SUBJECT: CERTIFICATION OF THE MINUTES OF THE ACRS SUBCOMMITTEE
ON THE UNITED STATES – ADVANCED PRESSURIZED WATER
REACTOR, MARCH 22-23, 2012

SUBJECT: MINUTES OF THE MEETING OF THE ACRS SUBCOMMITTEE ON THE
UNITED STATES – ADVANCED PRESSURIZED WATER REACTOR
ON MARCH 22-23, 2012, IN ROCKVILLE, MD

ADVISORY COMMITTEE ON REACTOR SAFEGUARDS
MINUTES OF THE ACRS US-APWR SUBCOMMITTEE MEETING
MARCH 22-23, 2012

9.1.3 Spent Fuel Pit Cooling and Purification System (SFPCS)

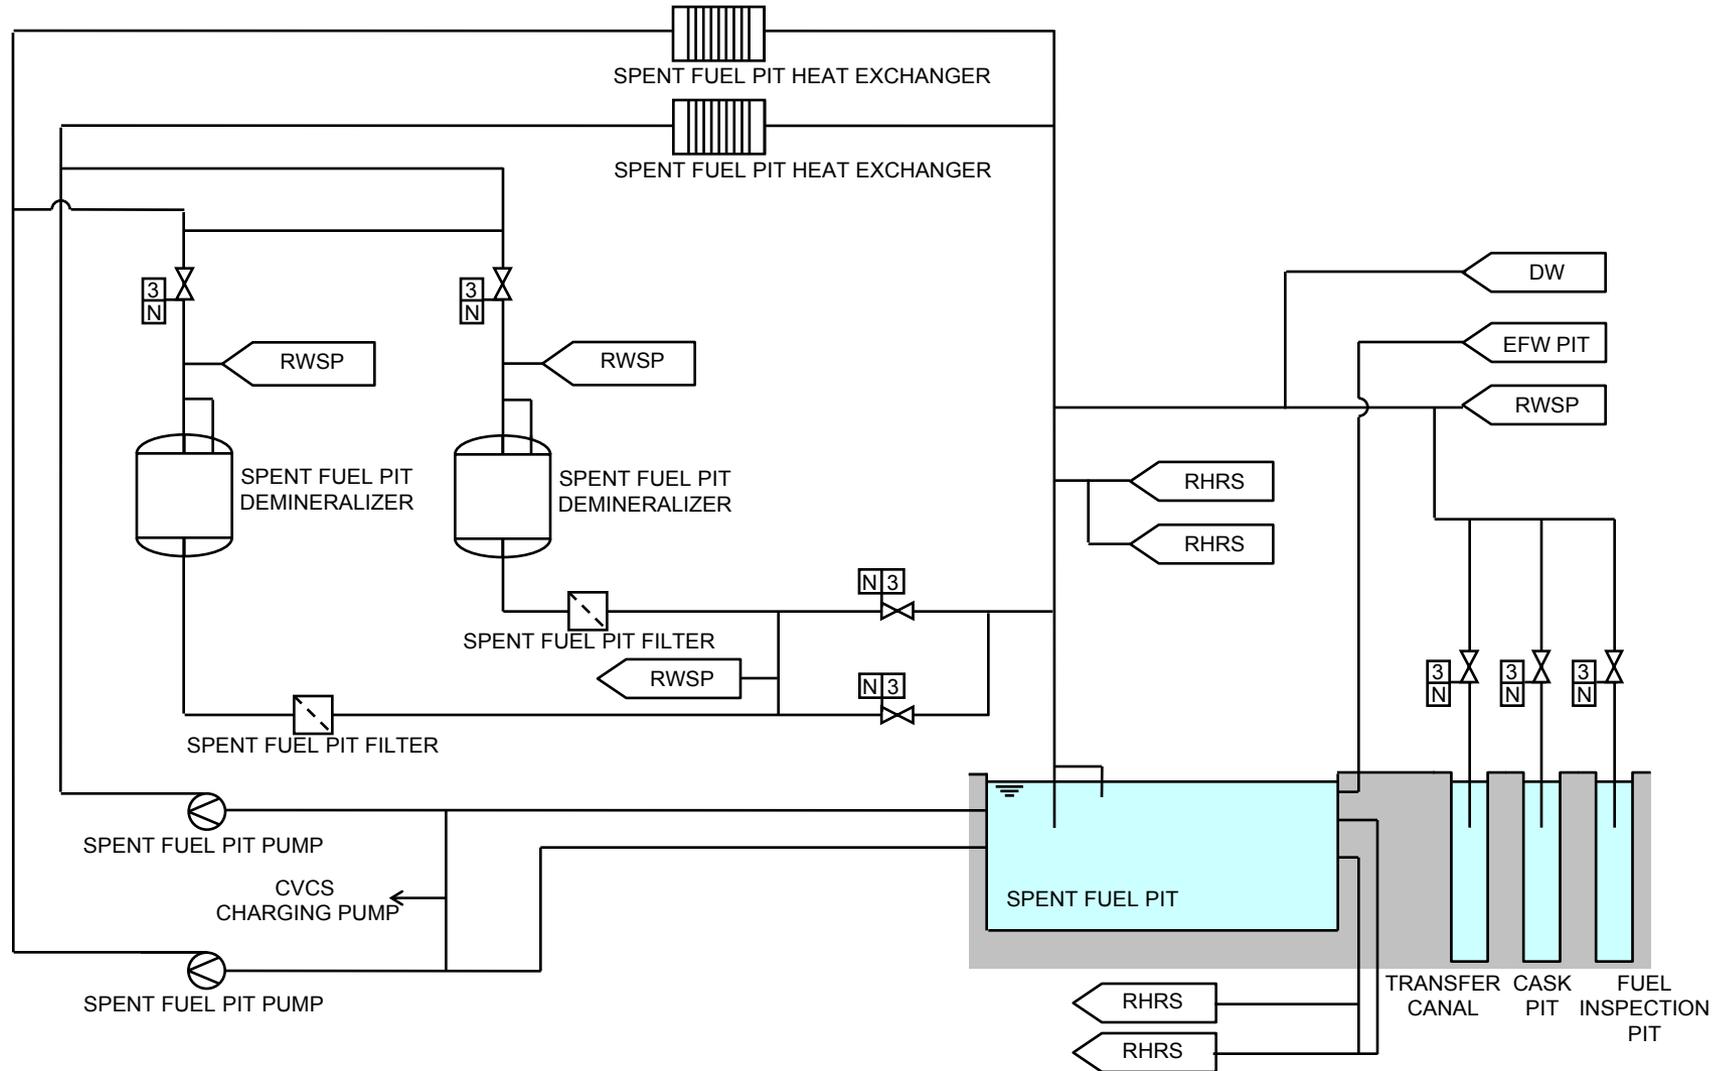
14 Thank you. Oh, one other question. Some
15 of these questions are basic configuration questions
16 that I had. This drawing -- just a simple question.
17 I think I know the answer to this. I just want to
18 confirm it. On Figure 9.1.3-1 of the DCD, it's the
19 drawing -- it's essentially the DCD drawing of what
20 you have on the screen here.

21 The containment spray RHR cooling line
22 suction elevations on that drawing are shown lower
23 than the spent fuel pit cooling suction lines at a
24 lower elevation. I didn't know whether that's
25 actually the case or whether it's just the way to show

3 My question is are the containment spray
4 RHR suction lines located at the same elevation as the
5 spent fuel pit suction lines? I found a lot of
6 information in the DCD about the elevation of the
7 spent fuel pit suction lines. It may just be an
8 artifact of the way that drawing was put together to
9 show the two of them.

19 CHAIR STETKAR: That's interesting
20 because that still makes my question relevant. The
21 spent fuel pit demineralizers, as is shown on this
22 drawing, can be aligned for cleanup of the refueling
23 water storage pit. The line is coming in at the top.
24 You go through the demineralizer and go back out to
25 the refueling water storage pit recirculation pump --

8 The drawing you reflect, if you take the
9 one out of the DCD, gave the impression that there
10 were two level sensors but only one temperature
11 sensor. There's only one little stalk in there.
12 There's two things off of it but I don't know what --
13 I don't know the convention for that particular symbol
14 as to how many they are.

9.1.4 Light Load Handling System

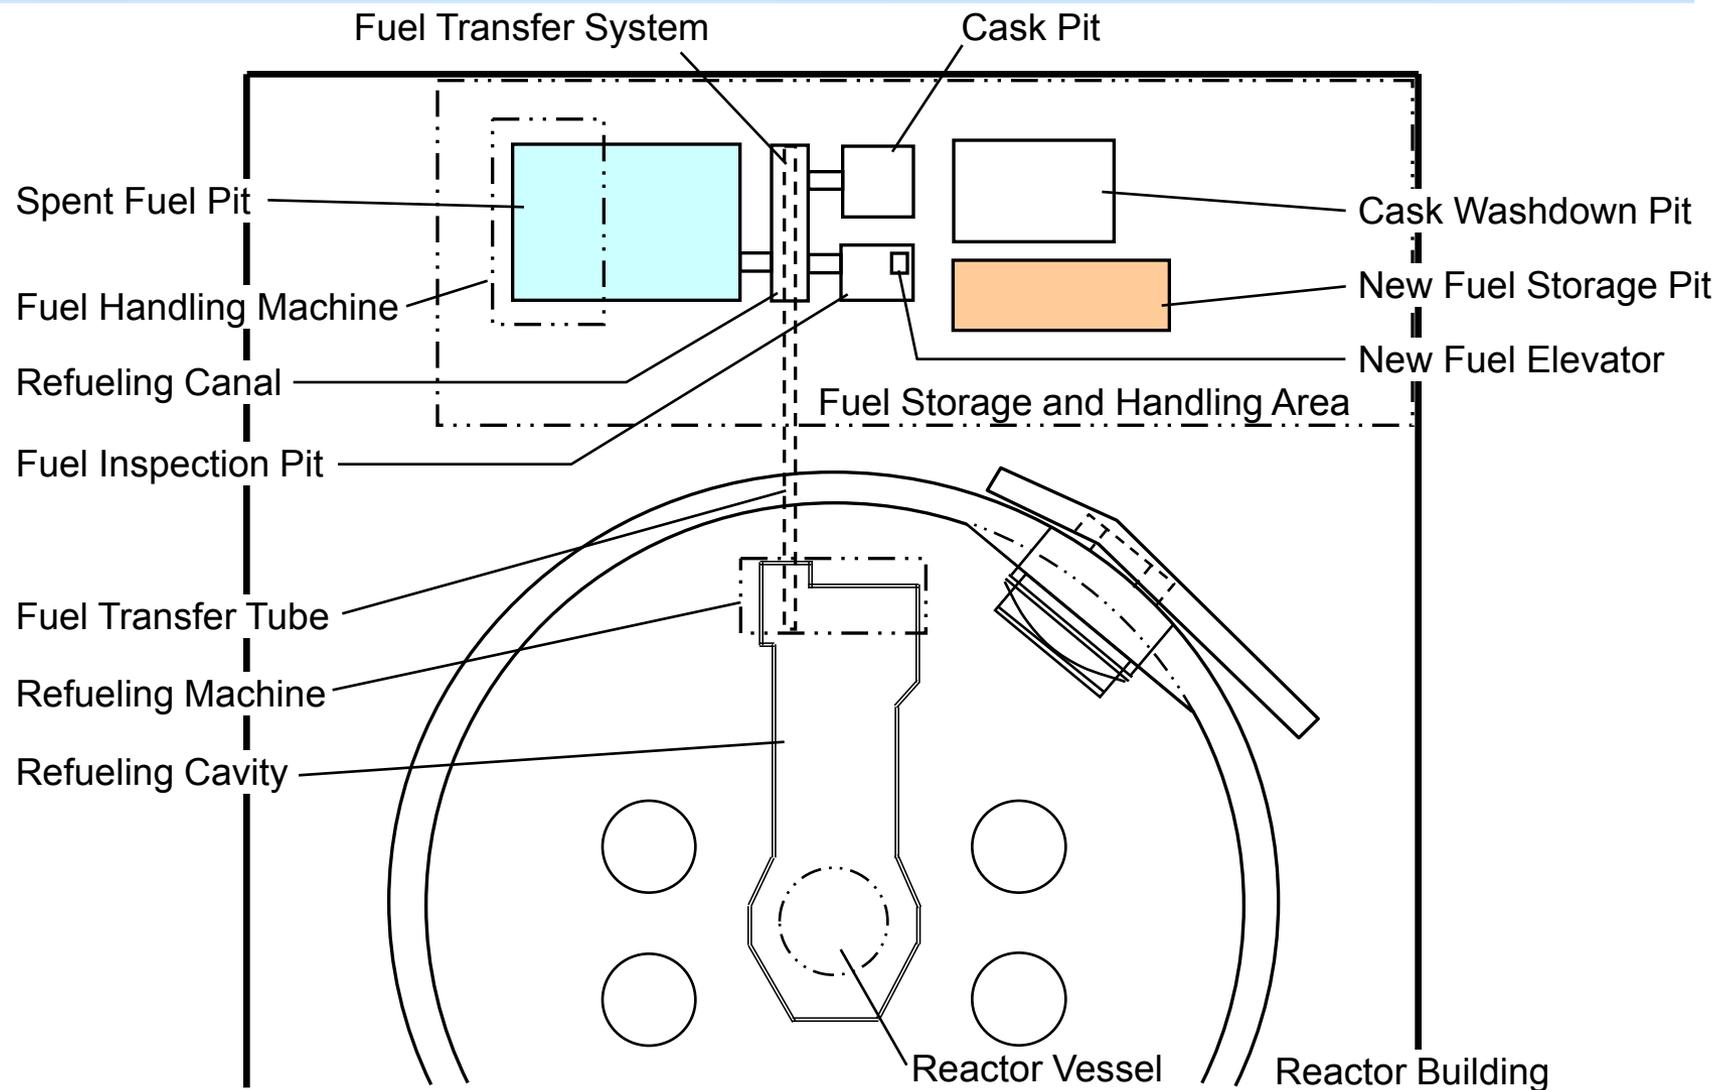
19 The question is, and it's difficult to
20 look at this elevation view and the plan view at the
21 same time. There are -- in this elevation view there
22 are weir walls. There are gates that separate the
23 spent fuel pit from the transfer canal and irrigates
24 that separate the cask pit and the fuel inspection pit
25 from the transfer canal.

1 Those weir walls, the gates, as best as I
2 can tell the bottom of the slot of the gate, in other
3 words if you remove the gate, the bottom of that slot
4 appears to be about, and I didn't have all of the
5 dimensions available, but about two-and-a-half feet
6 roughly above the top of the active fuel. It might be
7 a little bit more, might be a little bit less. I was
8 curious whether you know what that elevation
9 difference is.

16 CHAIR STETKAR: The elevation of what it
17 says weir is 47 feet 10 inches. The bottom of the
18 spent fuel pool is 30 feet one inch. The height of a
19 fuel assembly, if you look at the assembly that's in
20 the grappling hook there, is about 15 feet roughly.
21 If I add 15 feet to 30 feet, I come up to 45 feet
22 which gives me about 2.5 feet. That's sort of what I
23 was estimating but I didn't know if I was
24 misinterpreting something on this drawing.

16 There can be failures that may occur
17 while the weir gates are removed that could
18 conceivably drain the spent fuel pool level down to
19 the height of that weir wall, whatever that is. The
20 questions that I had, if those -- have you looked at -
21 - do you have any information about the time until
22 boiling would occur if you were drained to that level
23 and the time until fuel uncovering would start if
24 drained to that level?

10 As I said, some plant designs I've seen
11 have a drain line in that transfer tube connection and
12 many plants don't. It doesn't show on this 9.1.4-2 but
13 that's not the purpose of this figure. The purpose of
14 this figure is just to show the general configuration.
15 I was curious about is there a drain line. I don't
16 need the answer right now. If you don't have it, just
17 take it.

18 The other questions that I had about
19 possibly drain lines is are there drain lines from the
20 three volumes that you show on the right-hand side of
21 this figure, in particular a drain line from the
22 transfer canal, a drain line from the cask -- the pit,
23 and a drain line from the fuel inspection pit. I'm
24 assuming that there are because you need to drain
25 those somehow usually.

22 Again, we need to follow up on your
23 question from earlier but the piping and dates are
24 arranged so that a failure will not result in a level
25 less than 11.1 feet above the top of the assembly. We

9.2.2 Component Cooling Water System (CCWS)

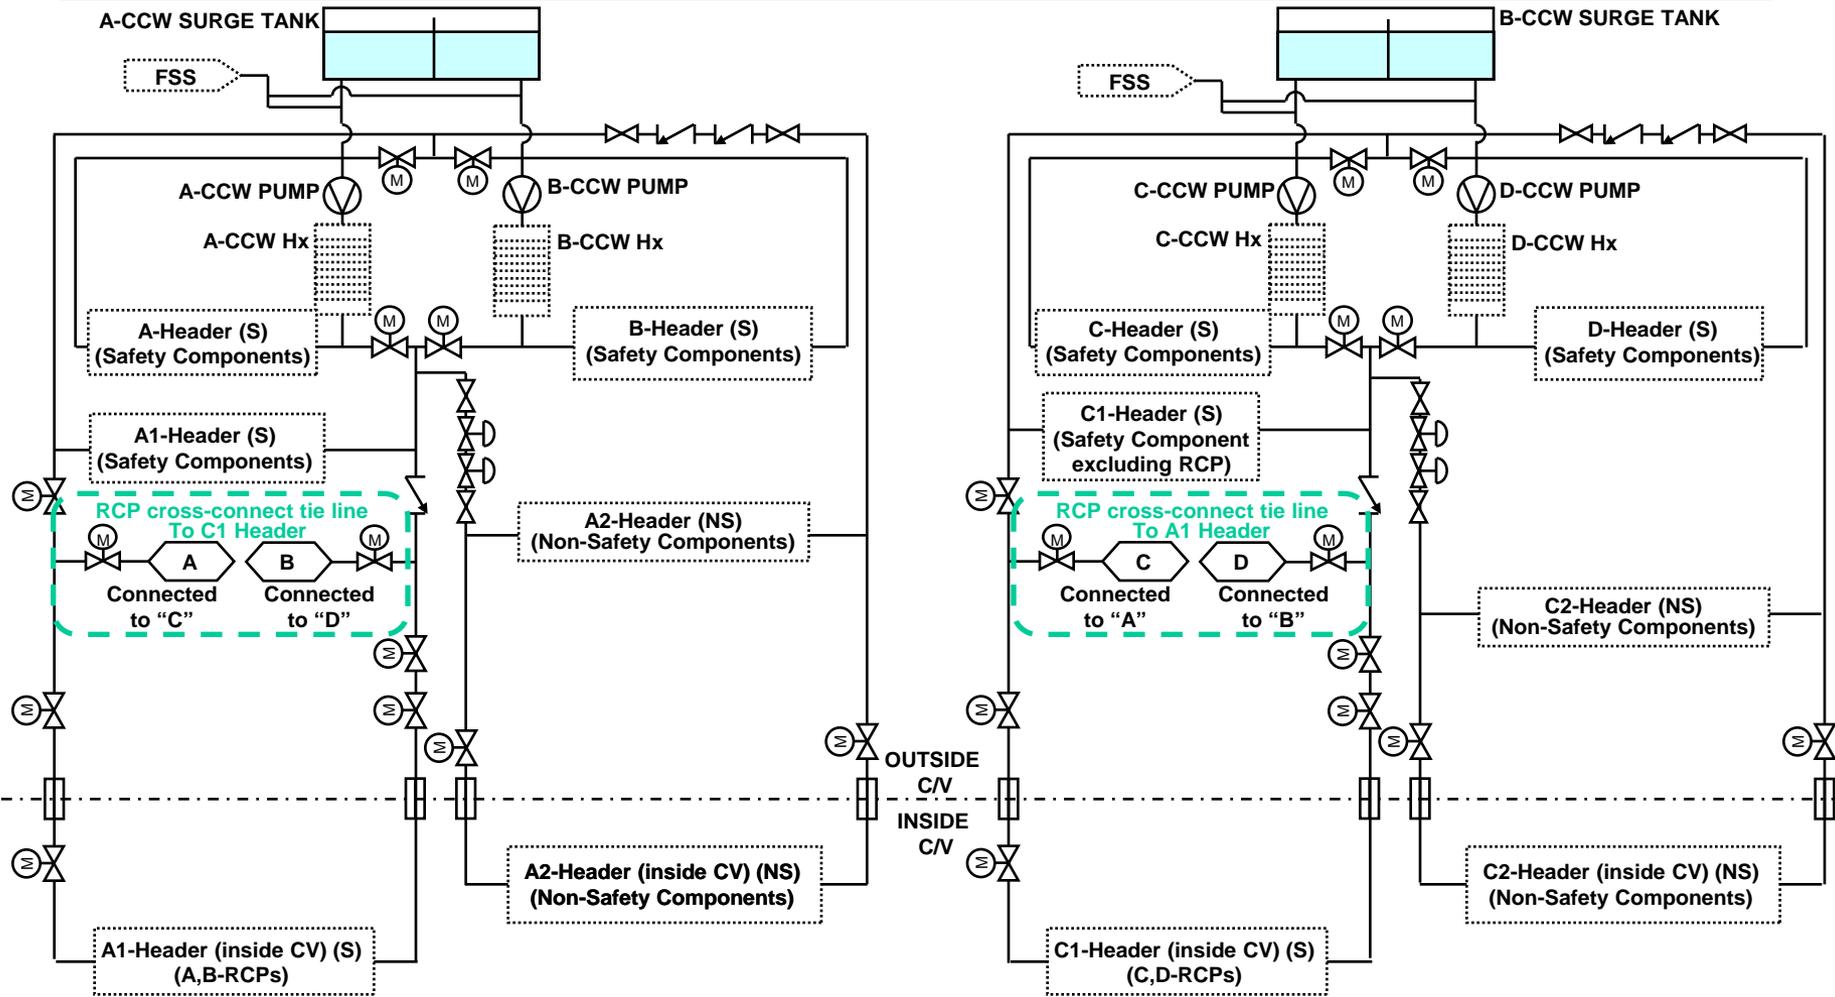
15 Just looking on Sheet 5 I could -- the
16 concern I originally had is looking at Sheet 5 if I
17 broke the piping on the drawing that you have here in
18 front of me, I could only find one isolation valve to
19 isolate the CCW header from that break.

4 Now, what I -- because I was looking at
5 drawings I didn't quite understand the second part
6 because this -- is the piping that's shown on this
7 drawing seismically qualified? If it is, where is it
8 seismically qualified? Because the way to supply
9 component cooling water now to the fan coolers, that
10 connection is shown on Sheet 5 of 9.2.2-1.

18 Now, given the fact that I'm slowly
19 starting to understand these interconnections, my
20 question now is the two locked closed valves that are
21 mentioned in the SER, are those the two normally
22 closed motor-operated valves that appear on Figure
23 9.2.2-1, Sheet 5, of the DCD in the lower left-hand
24 corner?

9 9.2.2-1, Sheet 6 is between safety and
10 non-safety. The valve is double isolation. The
11 other, Chapter 5, is a connection between CCW to the
12 containment cooling -- cooling pump. That is a
13 connection between the non-safety. That line is
14 containment non-safety line to non-safety containment
15 cooling. Isolation valve is only one.

9.4.3 Auxiliary Building Ventilation System

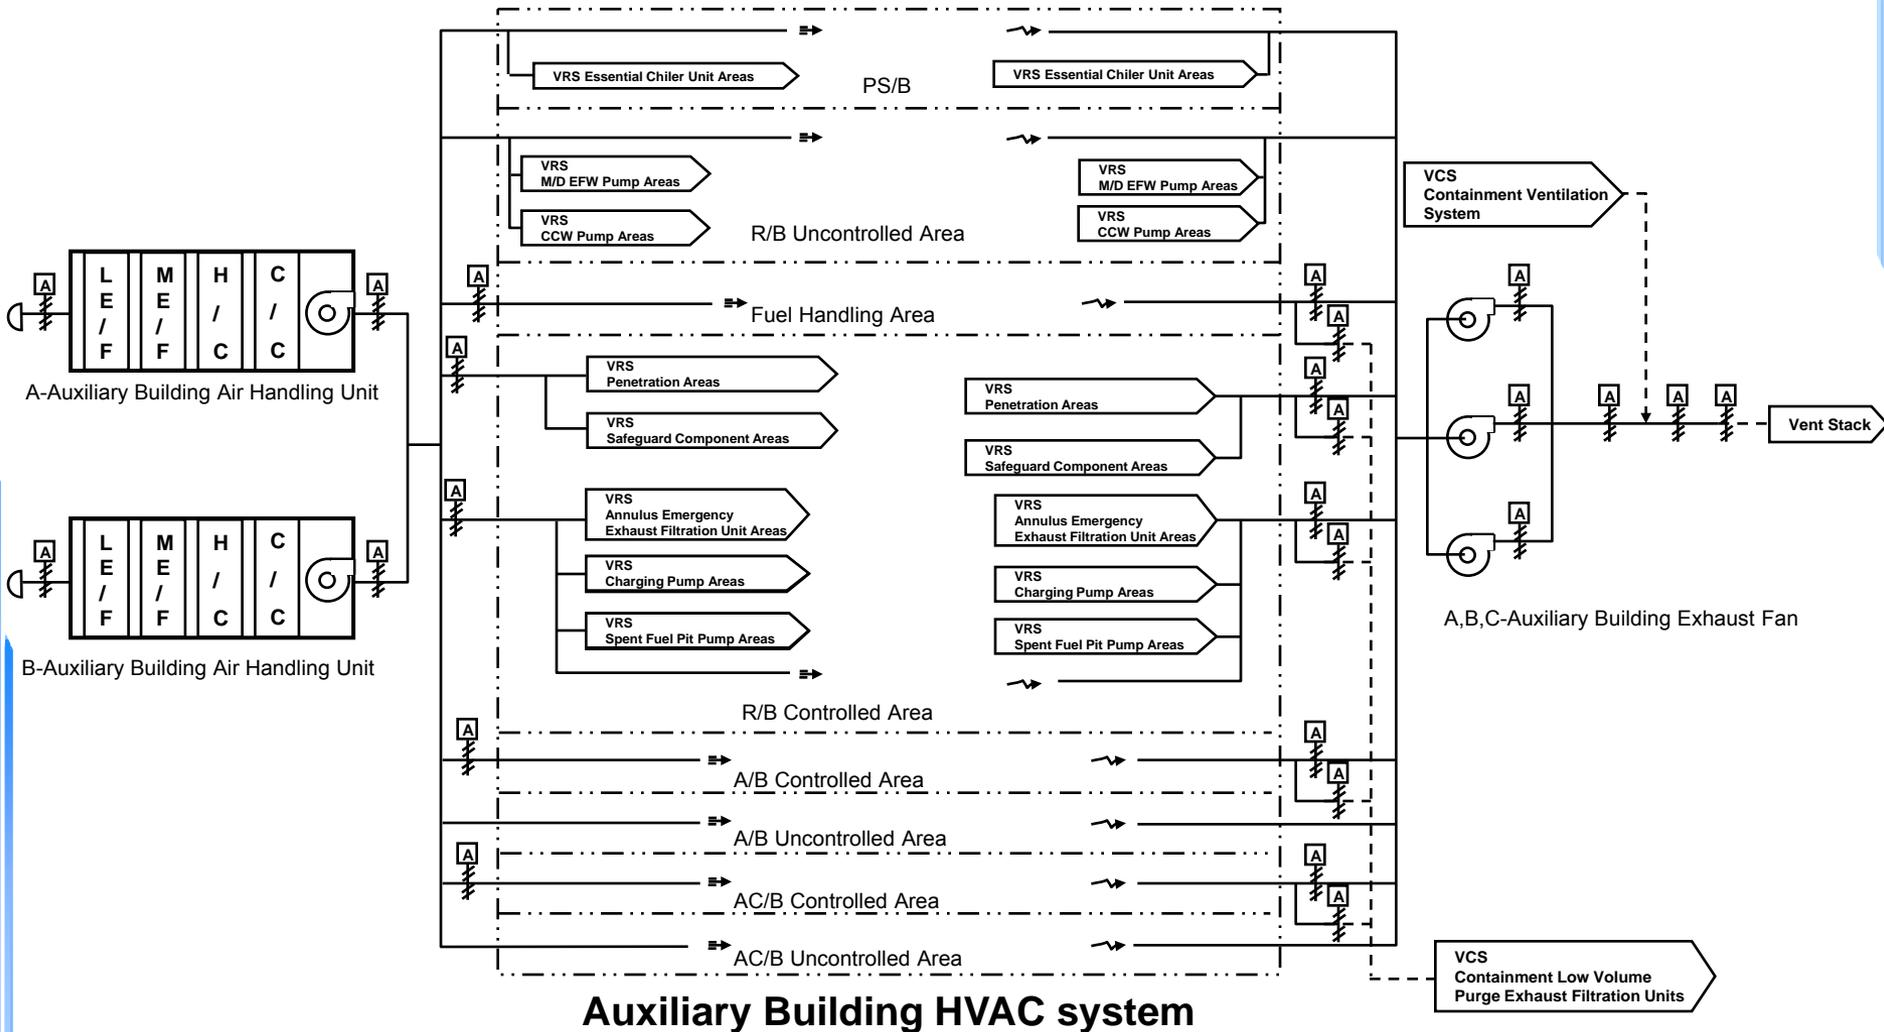
RAI No.	Question 09.04.03-X	RAI Topic / NRC Concern	RAI Response / DCD Impact
831-6030	21	<u>Open Item 09.04.03-21</u> Revise DCD Figure 9.4.3-1 (ABVS) to reflect the existence of backdraft dampers.	➤MHI provided: ✓DCD Subsection 9.4.3.2.1 system description will be revised to describe the backdraft dampers. The description is broadly applicable and inclusive of auxiliary building HVAC system branch ducts supplying or exhausting uncontrolled areas that may not be shown on the simplified flow diagram. Therefore, it is not practical or necessary to show the backdraft dampers on DCD Figure 9.4.3-1.
